CERTIFICATE OF APPROPRIATENESS

Property: 8503 Glencrest Street, Lot 24, Block 12, Glenbrook Valley Sec 6 Subdivision. The property includes a 1,502 square foot, one-story, wood frame and brick veneer single-family residence and attached garage situated on a 8,334 square foot interior lot.

Proposal: Alteration – In March 2016, the proposal to remove the partial height, brick front porch wall the spans the front walkway of the residence was denied by the HAHC.

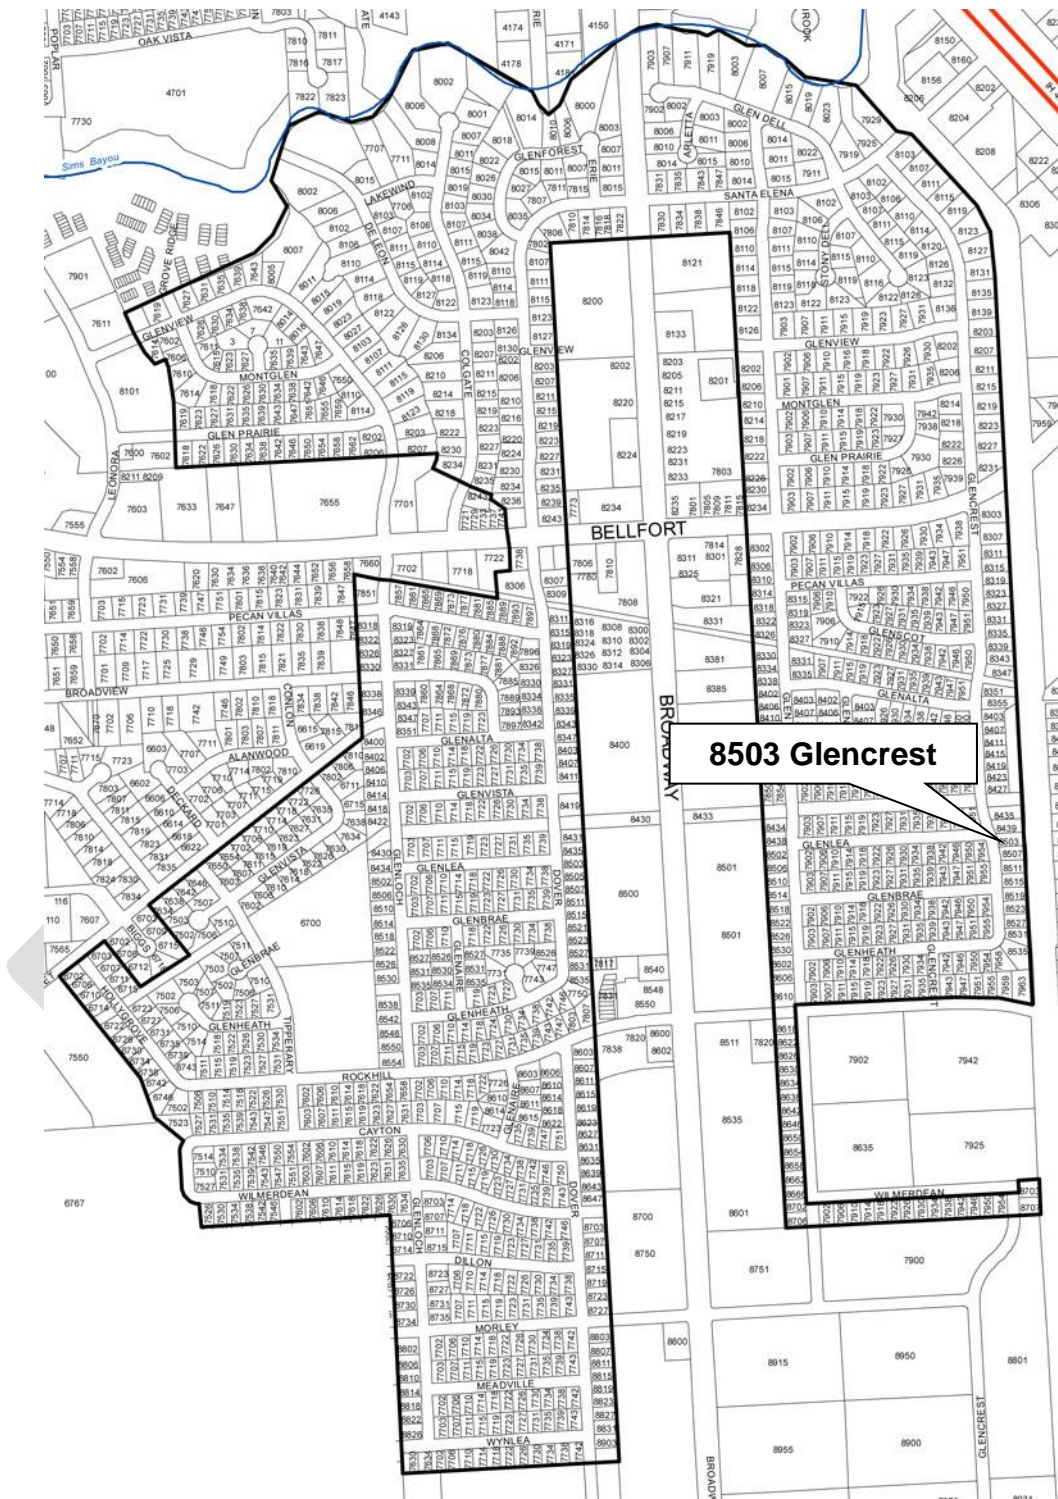
- ☒ ☐ ☐ (a) The proposed activity must recognize the building, structure, object or site as a product of its own time and avoid alterations that seek to create an earlier or later appearance; and

- ☒ ☐ ☐ (b) The proposed activity must match the architectural features, materials, and character of either the existing noncontributing structure or the contributing structures within the context area.
